**SERVICE BULLETIN
&
TECHNICAL SERVICE INFORMATION**

SERVICE BULLETIN
95-001

GAME: NIGHTWARRIORS™ DARKSTALKERS REVENGE

REF: OPERATORS MANUAL CORRECTION

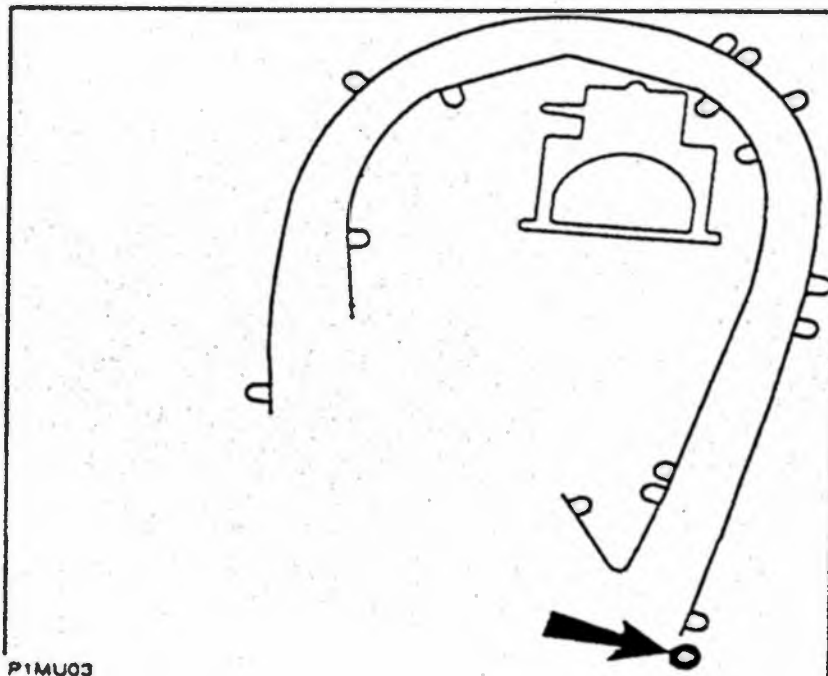
SUBJECT: BALL DRAIN WHEN EXITING ORBIT SHOT

REASON FOR BULLETIN: BALL DEFLECTS OFF OF RUBBER BUMPER WHEN EXITING ORBIT.

WHEN SHOOTING THE ORBIT SHOT FROM LEFT TO RIGHT, THE BALL SHOULD HIT THE RIGHT SIDE FLIPPER BAT. IF THE BALL EXITS BETWEEN THE TWO FLIPPERS CHECK, TO SEE IF THERE IS A RUBBER BUMPER ON THE POST AT THE EDGE OF THE ORBIT SHOT. SEE ARROW IN DRAWING BELOW:

"IF THERE IS A BLACK RUBBER BUMPER ON THIS POST." REMOVE SCREW IN PLASTIC TO THE REAR OF THE TOP HAT. FLEX PLASTIC AND REMOVE RUBBER BUMPER. REINSTALL SCREW.

“A”

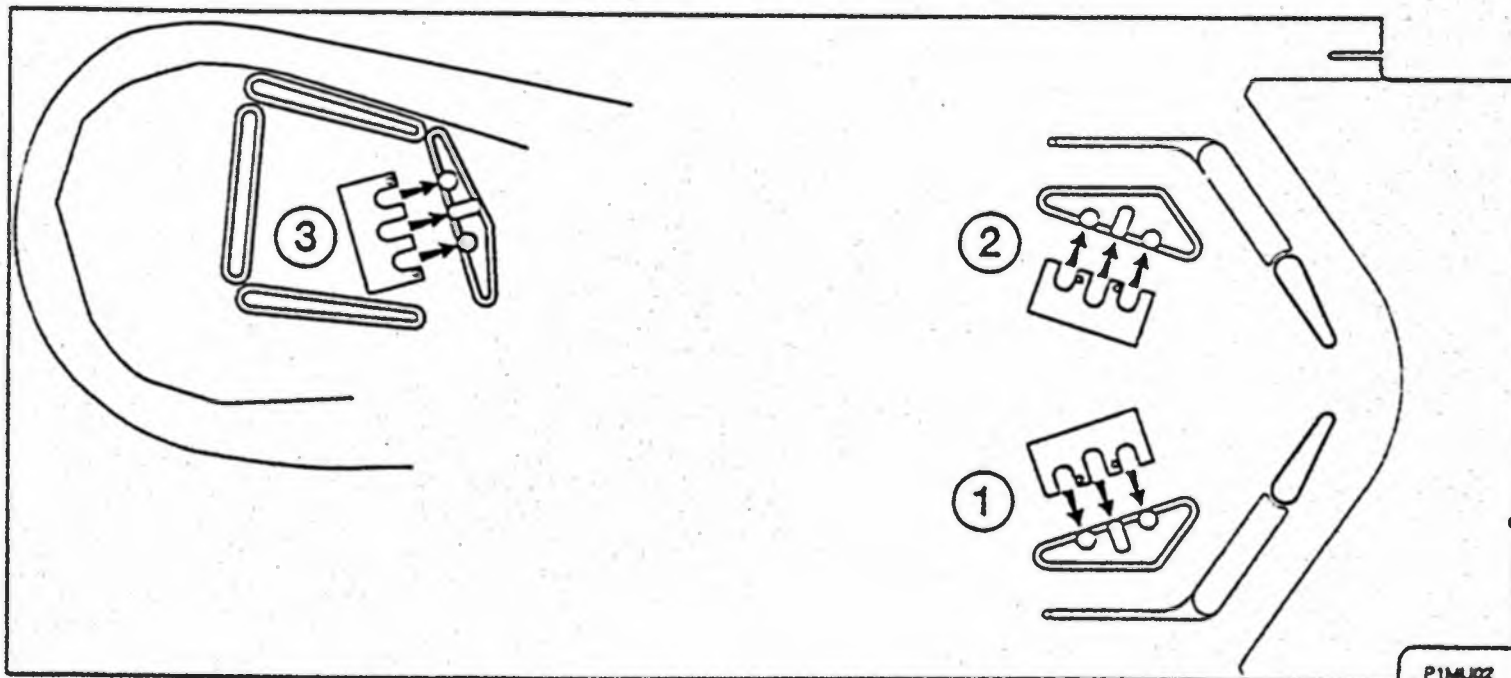
SUBJECT: RETRO FIT KIT FOR MAGIC™. SLING SHOTS, AND FLIPPERS.

1. REMOVE FRONT SCREW, POST & WASHERS OFF THE FRONT OF PLASTIC RAMP OVER THE LOWER LEFT SLINGSHOT.
2. REMOVE THE 2 NUTS OFF OF THE SLINGSHOT PLASTIC PN AW00123-9.
3. REMOVE 3" RUBBER RING AND DISCARD.
4. SLIDE THE LOWER LEFT SLINGSHOT TEMPLATE IN POSITION, ALIGNING THE EDGE OF THE THREE HOLES IN THE PLAYFIELD WITH THE BLACK LINE OF THE TEMPLATE.
5. USING A CENTER PUNCH MARK THE PLAYFIELD OVER THE 2 X's.
6. DRILL THE TWO HOLES WITH A 2mm 1/16" DRILL.
7. INSTALL NEW POST PN SM00151 IN THE TWO HOLES NEAR THE SWITCH HOLES.
8. INSTALL NEW 2 3/4" RUBBER PN RB00108-11.
9. REINSTALL PLASTIC.
10. REINSTALL PLASTIC RAMP.

1. REMOVE LOWER NUT AND TWO WASHERS OFF OF THE WIRE RAMP.
2. REMOVE THE TWO NUTS OFF OF THE PLASTIC.
3. REMOVE SLINGSHOT PLASTIC PN AW00123-8.
4. REMOVE 3" RUBBER RING AND DISCARD.
5. SLIDE THE LOWER RIGHT SLINGSHOT TEMPLATE IN POSITION, ALIGNING THE EDGE OF THE THREE HOLES IN THE PLAYFIELD WITH THE BLACK LINE OF THE TEMPLATE.
6. DRILL THE TWO HOLES WITH A 2mm 1/16" DRILL.
7. USING A CENTER PUNCH MARK THE PLAYFIELD OVER THE 2 X's.
8. INSTALL NEW POST PN SM00151 IN THE TWO HOLES NEAR THE SWITCH HOLES.
9. INSTALL NEW 2 3/4" RUBBER PN RB00108-11.
10. REINSTALL PLASTIC.
11. REINSTALL WIRE RAMP TWO WASHERS AND NUT.

1. REMOVE THE 3 NUTS AND ONE SCREW OFF OF PLASTIC OVER STAR BUMPER UPPER PN AW0123-12, AND LOWER PN AW0123-22..
2. REMOVE PLASTIC OVER SLINGSHOT ASSEMBLY.
3. SLIDE THE UPPER SLINGSHOT TEMPLATE IN POSITION, ALIGNING THE EDGE OF THE THREE HOLES IN THE PLAYFIELD WITH THE BLACK LINE OF THE TEMPLATE.
4. USING A CENTER PUNCH MARK THE PLAYFIELD OVER THE 2 X's
6. DRILL THE TWO HOLES WITH A 2mm 1/16" DRILL.
7. INSTALL NEW POST PN SN00151 IN THE TWO HOLES NEAR THE SWITCH HOLES.
8. REINSTALL PLASTIC.
